SECTION 4.55 MODIFICATION ASSESSMENT REPORT

Broken Hill City Library Refurbishment

DA MOD 6/2020 (PAN-265207)

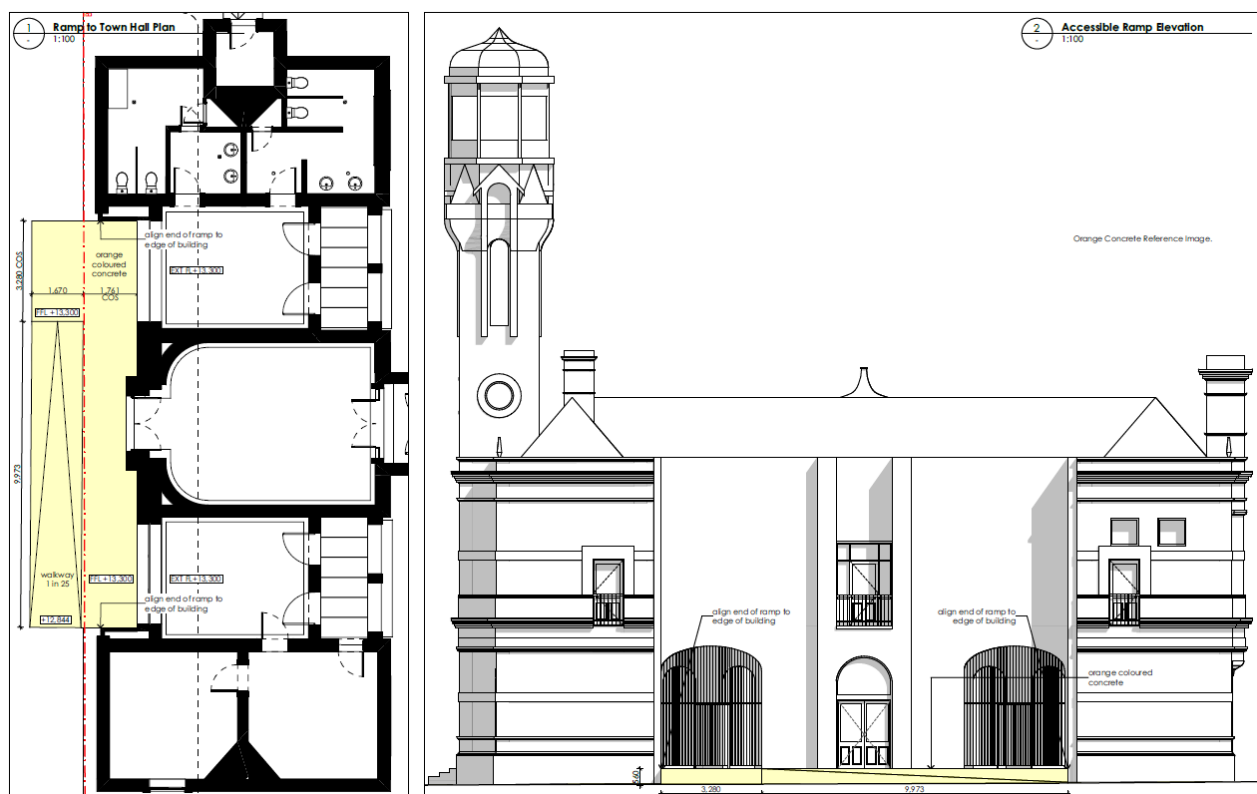
Additional detail of the Town Hall Rear Elevation was requested to better understand the location and relationship of the disabled access ramp and with the Town Hall building.

This detail was deemed to be sufficient for the purpose of understanding the proposed work. No further concerns were raised in relation to the need for additional plans.

- *Prior to the issue of the Construction Certificate, advice and/or construction detail plans are to be obtained from a qualified and practicing Heritage Architect detailing how to treat and/or construct the disabled access ramp against the town hall rear façade to prevent rising damp from occurring. Details to be provided with the application for the Construction Certificate.*

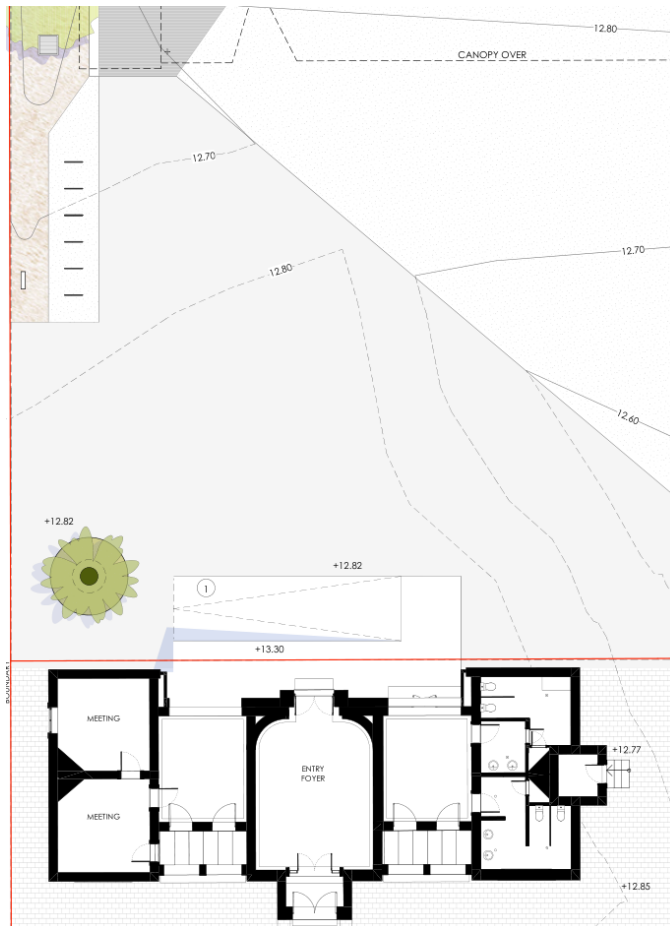
The Heritage Advisor raised concern about the lack of landscaping detail to the open space behind the Town Hall Façade. As shown in the **Figure** below, there is a tree and bike rack proposed in this space only. The concern raised was that without landscaping (for example: Detailing of paving, any seating, shading devices and tree planting etc.), this space could be hot and an unfriendly space for users.

- *Prior to the issue of the Construction Certificate, the landscaping detail proposed to the open space behind the Town Hall must be provided to the satisfaction of Council’s Heritage Advisor. Written evidence of the Heritage Advisor’s satisfaction with the end design for this space must be submitted with the application for the Construction Certificate.*
